**DEPARTMENT OF TRANSPORTATION**

Contract #: 04-0120F4Cty: SF/ALA Rte: 80 PM: 13.2/13.9File #: 69.25B**QUALITY ASSURANCE -- NON-CONFORMANCE REPORT****Location:** Changxing Island, Shanghai, P.R. China**Report No:** NCR-000709**Prime Contractor:** American Bridge/Fluor Enterprises, a JV**Date:** 15-Apr-2010**Submitting Contractor:** Zhenhua Port Machinery Company, Ltd (ZPMC), Changxing Island**NCR #:** ZPMC-0676**Type of problem:**

**Reference Description:** Missed UT indications by QC on Segment 9DE: Edge Plate to Deck Plate weld and Edge Plate Stiffener to FL3 weld

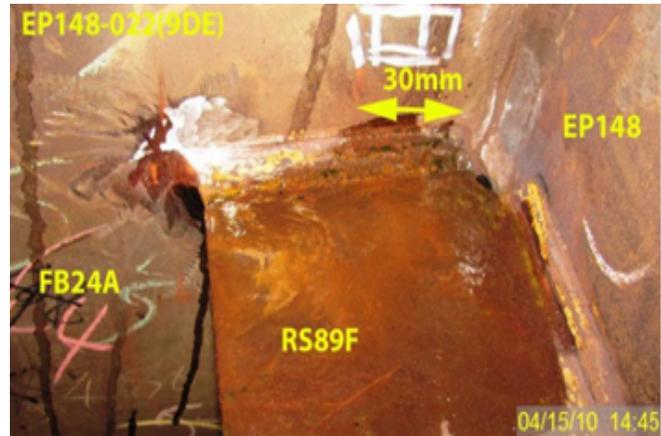
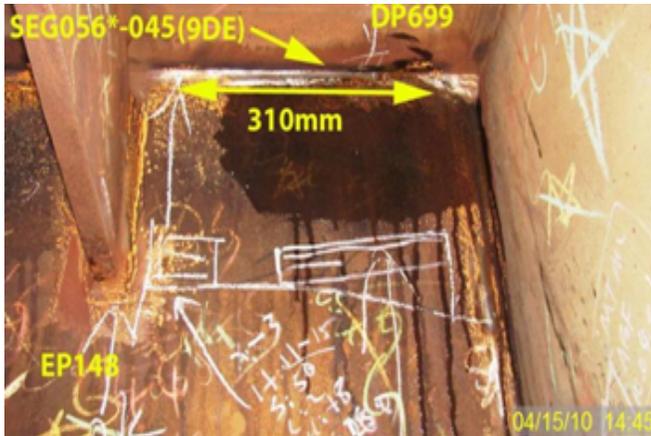
During the Quality Assurance (QA) Ultrasonic Testing (UT) review of welds located on Orthotropic Box Girder (OBG) Segment 9DE, this QA Inspector discovered the following issues:

- Two (2) longitudinal linear indications measuring approximately 310mm and 30mm in length.
- The indications dBs rating are +6 and +4.
- Material thickness is 18mm.
- The depth of the indications is approximately 11mm and 13mm.
- The welds are identified as SEG056\*-045 at Panel Point (PP) PP81.5 and EP148-022 at PP 81.
- The welds are designated as Seismic Performance Critical Material (SPCM).
- The indications are clearly marked on or near the weld.
- The Y distance for the indications are 50 mm from PP81.5 and 0 mm from EP148A.
- Weld SEG056\*-045 is a Complete Joint Penetration (CJP) Corner joint, joining the Edge Plate PL1336C (SPCM) to Deck Plate PL1314A (Non SPCM).
- Weld EP148-022 is a Complete Joint Penetration (CJP) "T" joint, joining the Edge Plate stiffener RS89F (Non SPCM) to FB24A plate PLX24D (SPCM).
- Segment 9DE is located outside of Paint shop.

The Notice of Witness Inspection (NWIT) No. is 005523. The indication is located in an area previously tested and accepted by ZPMC Quality Control (QC) personnel. As per the contract documents, ZPMC's QC personnel are required to perform hundred (100%) percent UT inspection of this weld.

**Reference Resolution:** ZPMC has repaired the missed indications and has performed the NDT after to show that the welds are acceptable. Based on this ZPMC requests closure of this NCR.

This proposed resolution is acceptable. The documentation received is sufficient and the Department concurs that Non-Conformance ZPMC-0676 is closed.
